JORDAN VALLEY WATER CONSERVANCY DISTRICT
11800 SOUTH U-111 PROJECT

NO.	DATE	DR	CHK	APVD
1		R. WILLEITNER	C. HOGGARD	N. JONES
1	02/10/2017	A2 - MODIFY PROFILE ON PRV VAULT

NO.	DATE	DR	CHK	REVISION	BY	APVD
1	01/27/2016	A1.14	REISSUE DRAWING			
2	02/08/2017	A2	ADJUST VIEW AND SHOW ELEC CONNECTION TO EXIST VAULT

PLAN AND PROFILE
STA 198+00 TO STA 208+00

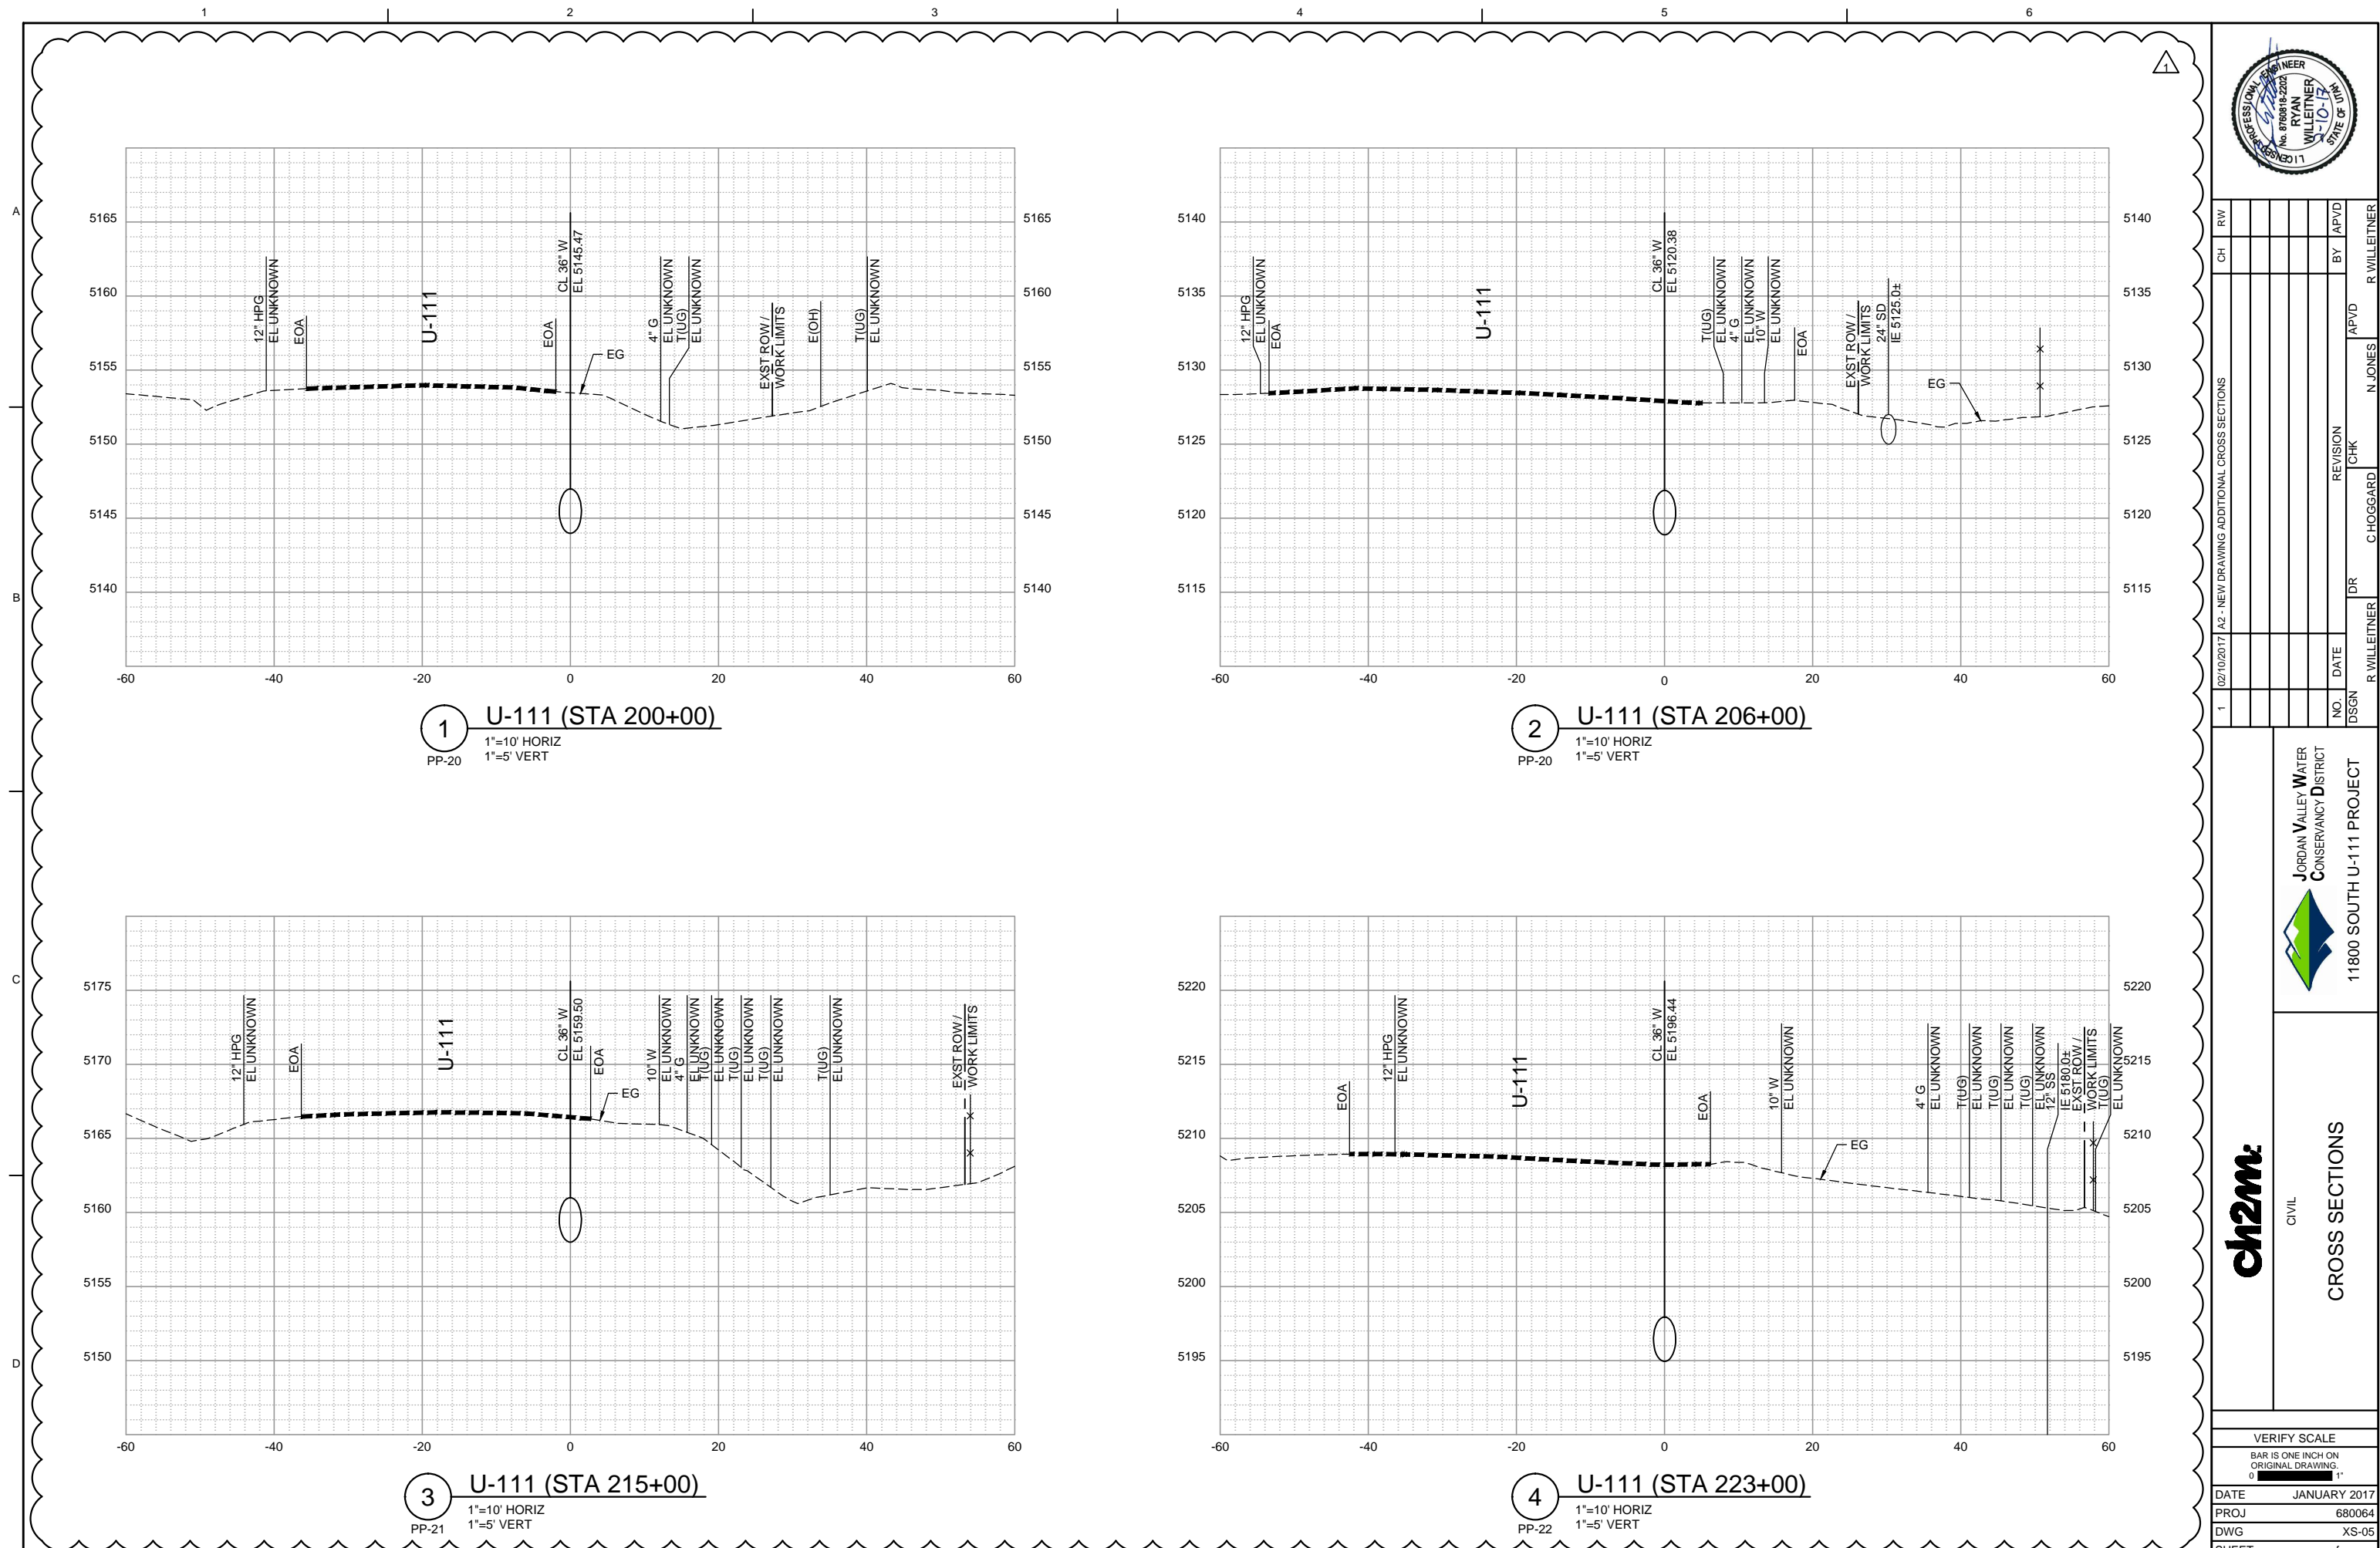
NO.	DATE	DR	CHK	APVD
1	02/10/2017	R. WILLEITNER	C. HOGGARD	N. JONES
DESCRIPTION		DESIGN	REVISION	BY
1		ADDED MISSING CULVERT CROSSING

ELECTRICAL
SITE PLAN
PRV VAULT

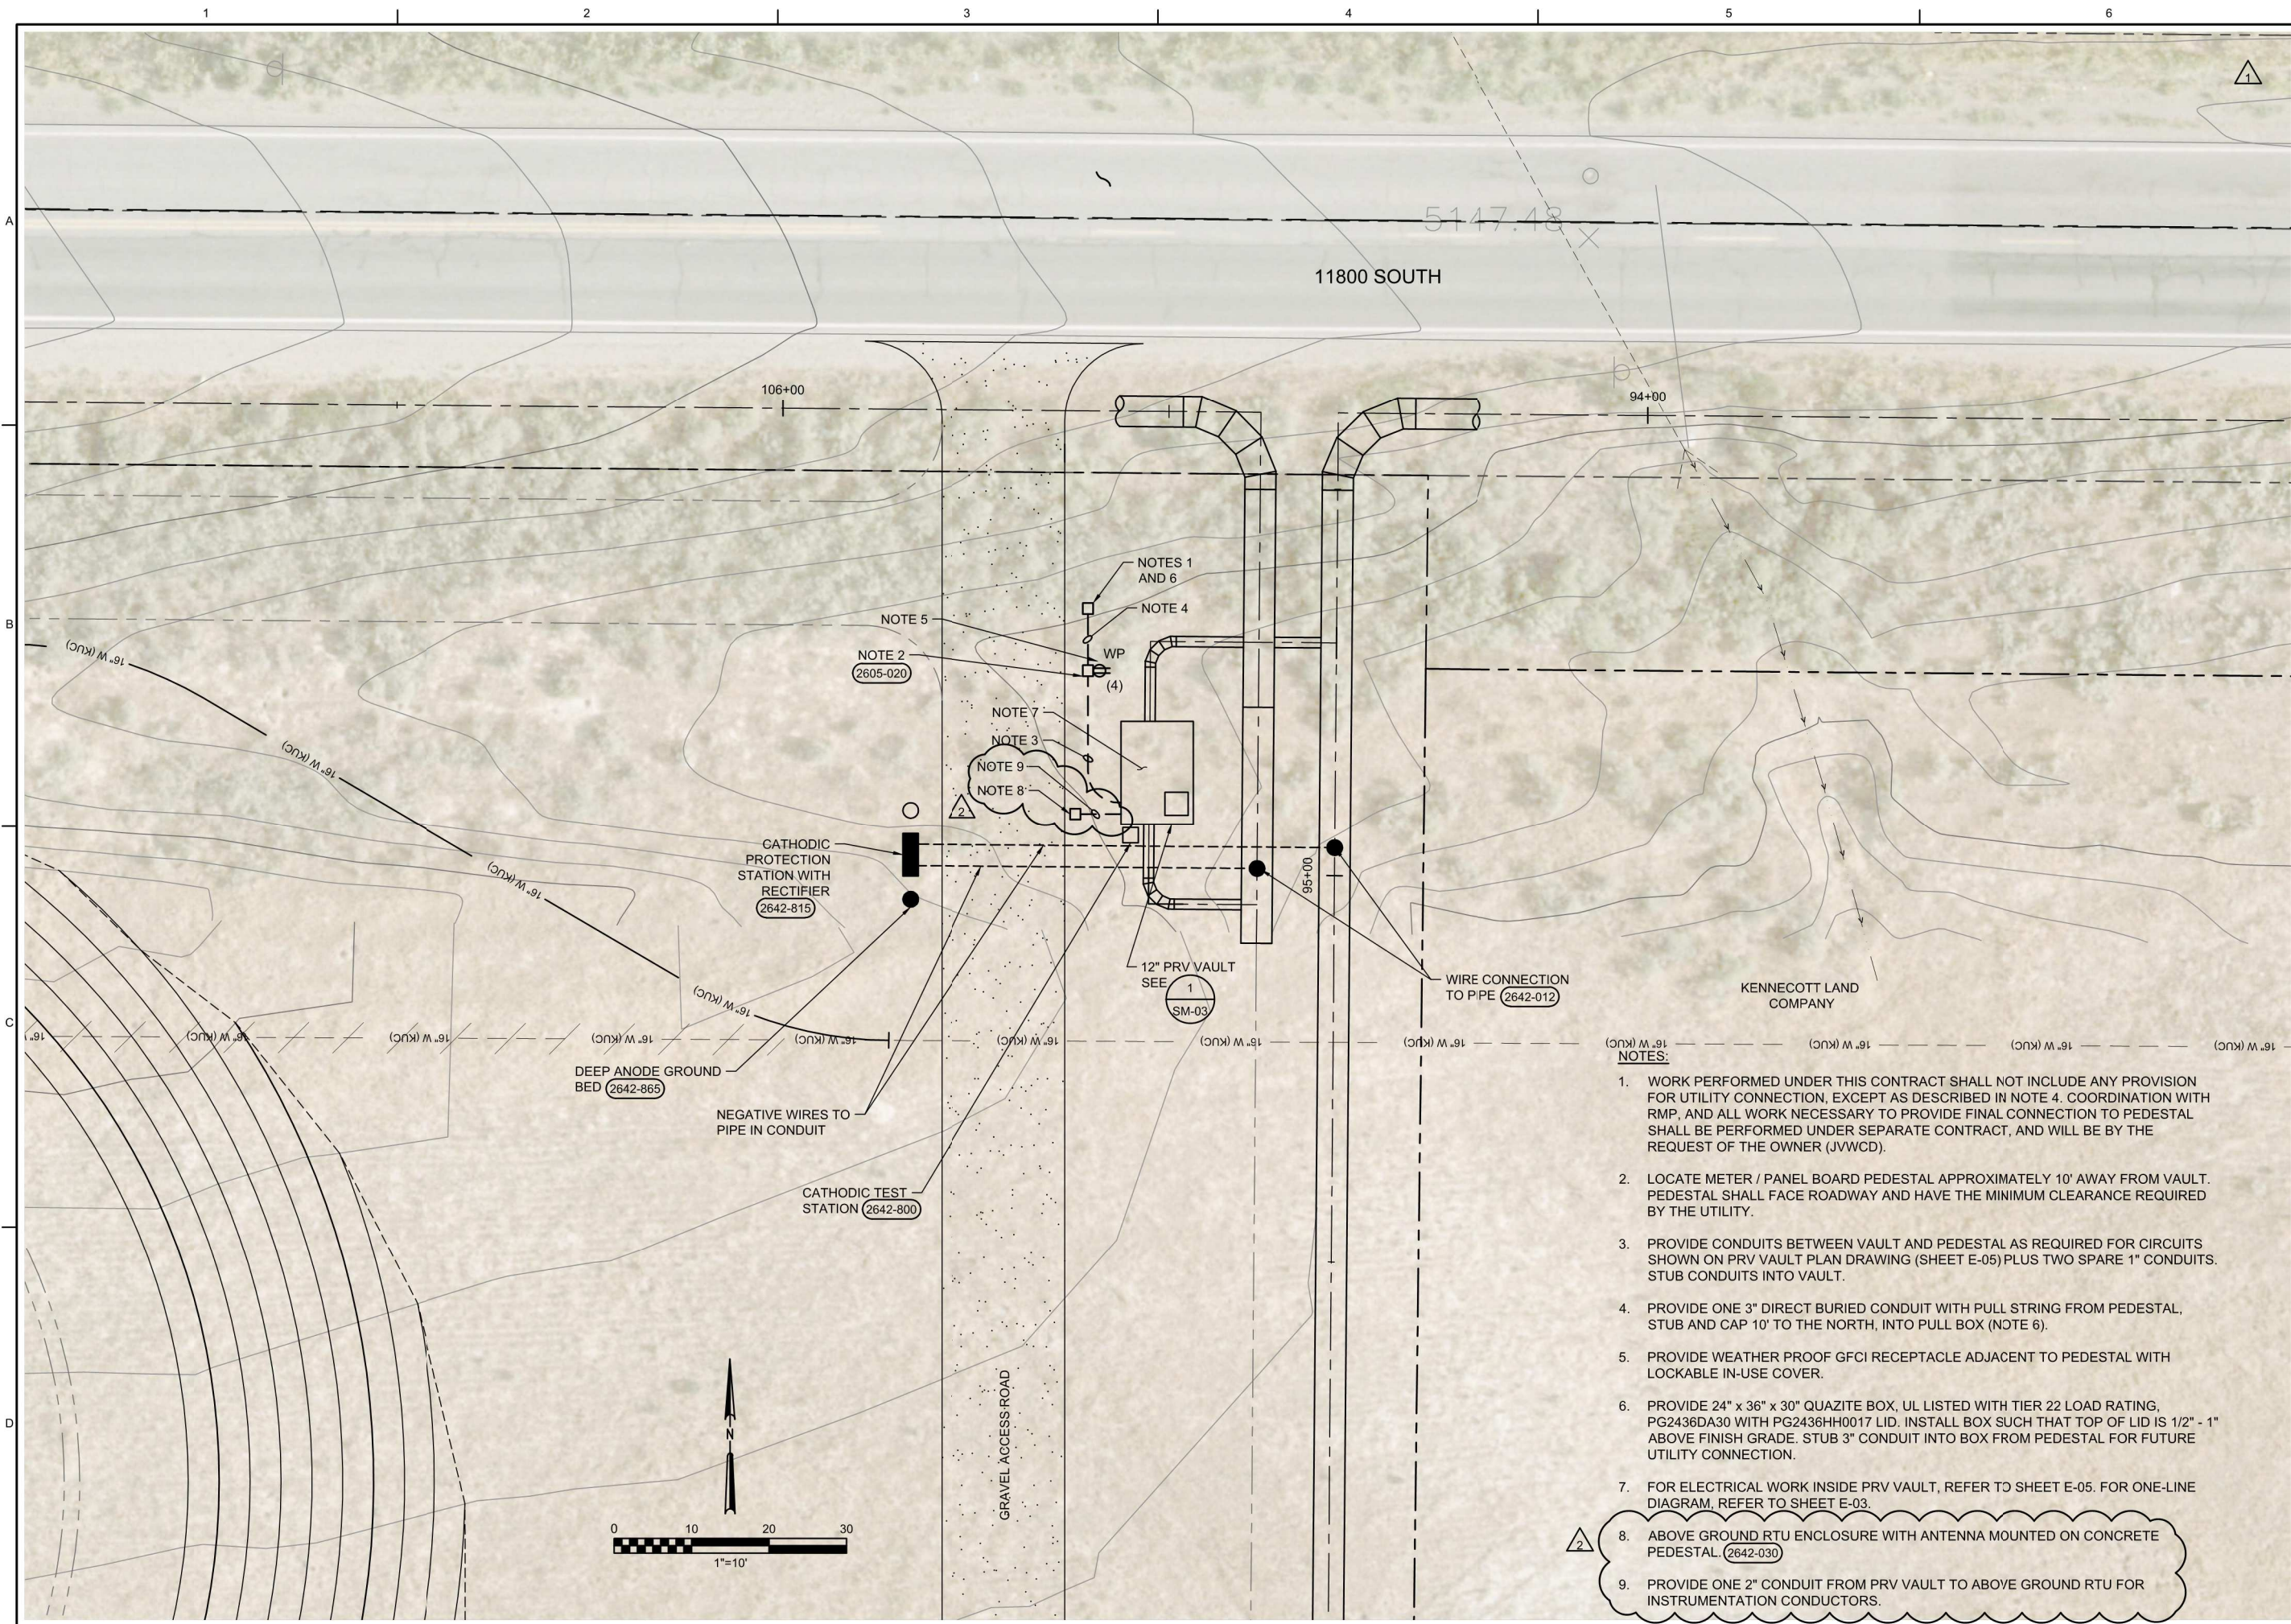
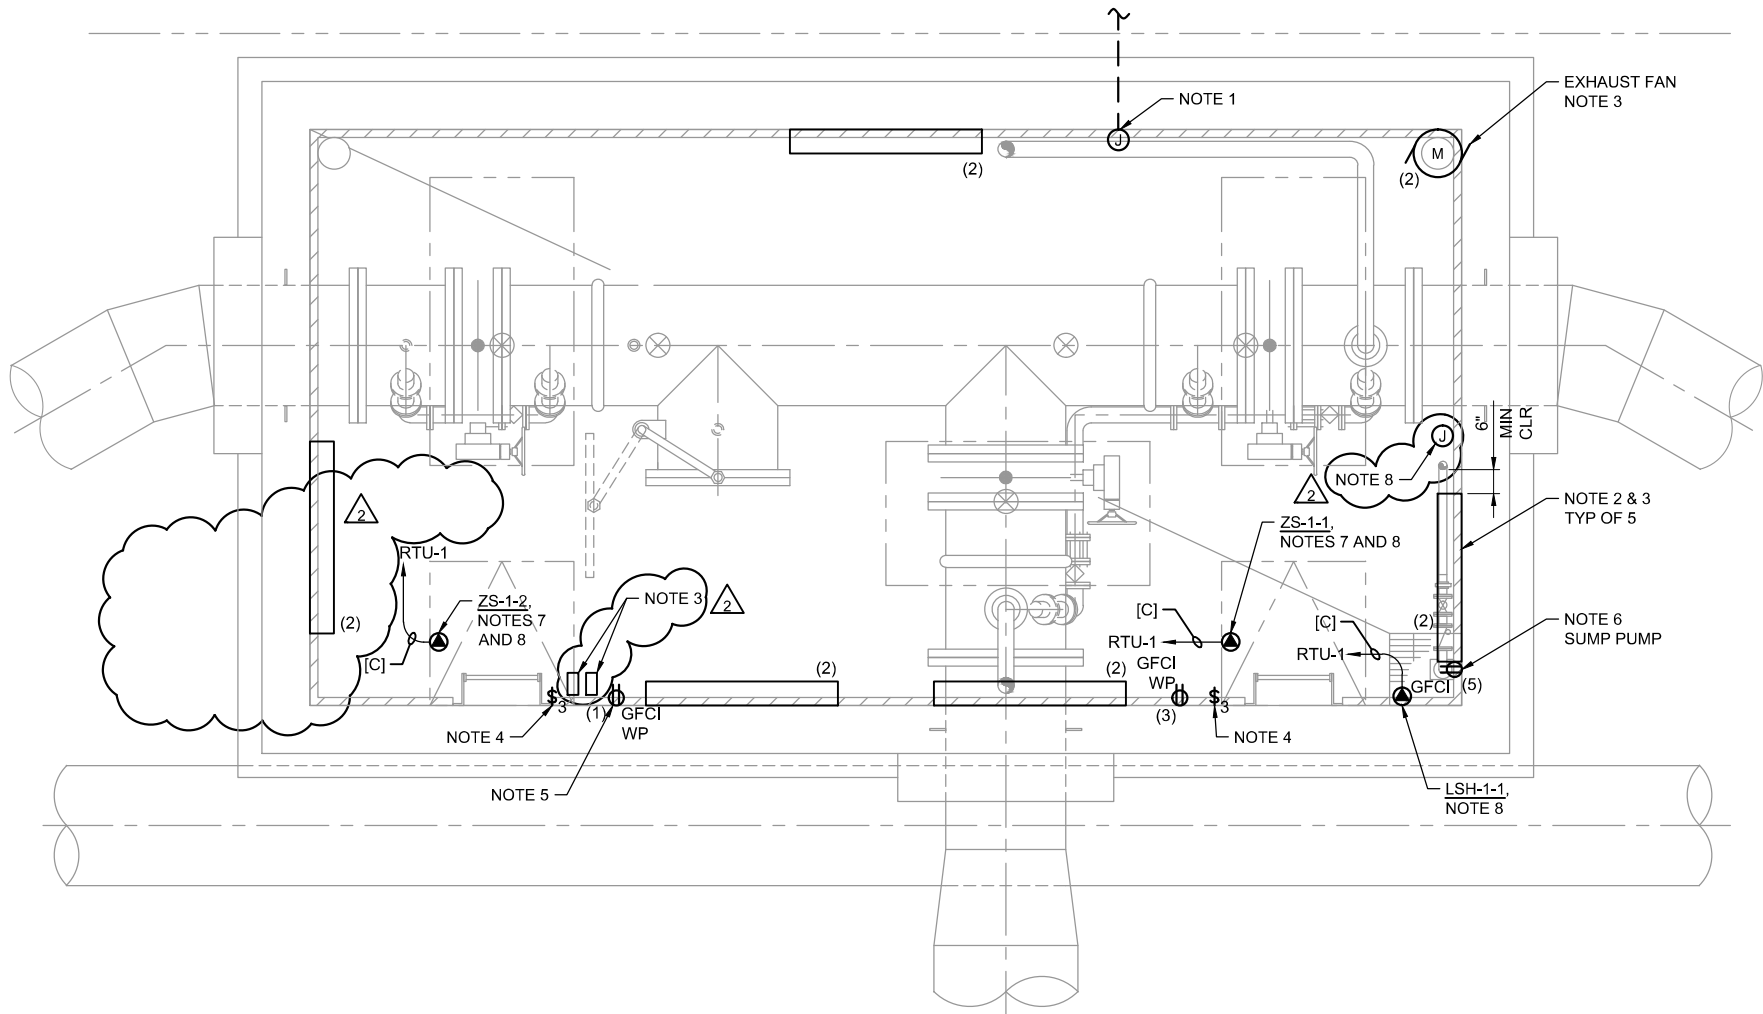
NO.	DATE	DSGN	DR	CHK	REVISION	BY	APVD
1	01/27/2016	A1.15 - REISSUE DRAWING	C WILLIAMS	C HOGGARD			C WILLIAMS
2	02/08/2017	A2 - ADD RTU ENCLOSURE AND CONDUIT					C CURTIS

- FOR ELECTRICAL WORK INSIDE PRV VAULT, REFER TO SHEET E-05. FOR ONE-LINE DIAGRAM, REFER TO SHEET E-03.
 - ABOVE GROUND RTU ENCLOSURE WITH ANTENNA MOUNTED ON CONCRETE PEDESTAL (2642-030)

- PROVIDE ONE 2" CONDUIT FROM PRV VAULT TO ABOVE GROUND RTU FOR INSTRUMENTATION CONDUCTORS.

ch2m
ELECTRICAL
ELECTRICAL PLAN
PRV VAULT

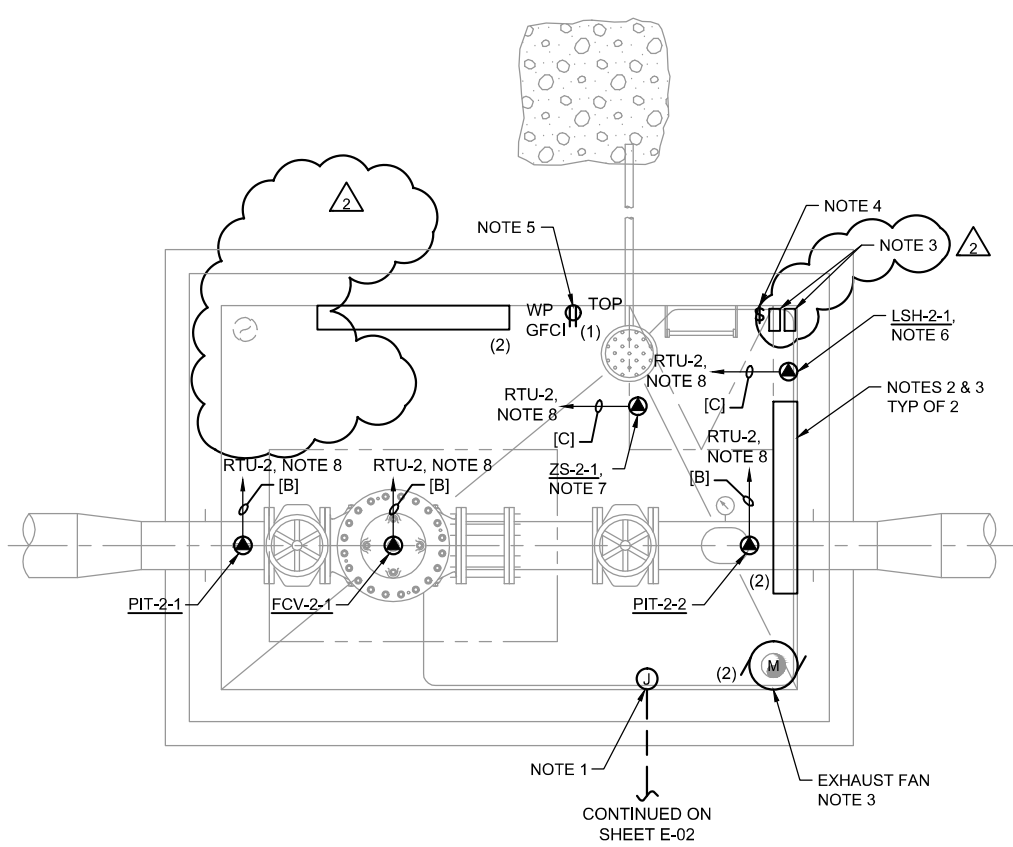
1	01/27/2016	A1.18 - REISSUE DRAWING	C WILLIAMS	DR	C WILLIAMS
2	02/08/2017	A2 - DELETE PANEL AND MAST ARM, ADD SWITCH AT ACCESS HATCH	C WILLIAMS	CHK	C WILLIAMS
			C HOGGARD	REVISION	C CURTIS
				NO. DATE	BY APVD

9. PROVIDE 36"x48"x18" ENCLOSED AND GASKETED NEMA 3R ENCLOSURE WITH BACKPLANE. TURN BACKPLANE OVER TO OWNER, AS SCADA COMPONENTS WILL BE PROVIDED AND INSTALLED BY OWNER. REFER TO SPECIFICATION SECTION 26 05 01.2.17. REFER TO SHEET E-02 FOR RTU LOCATION.
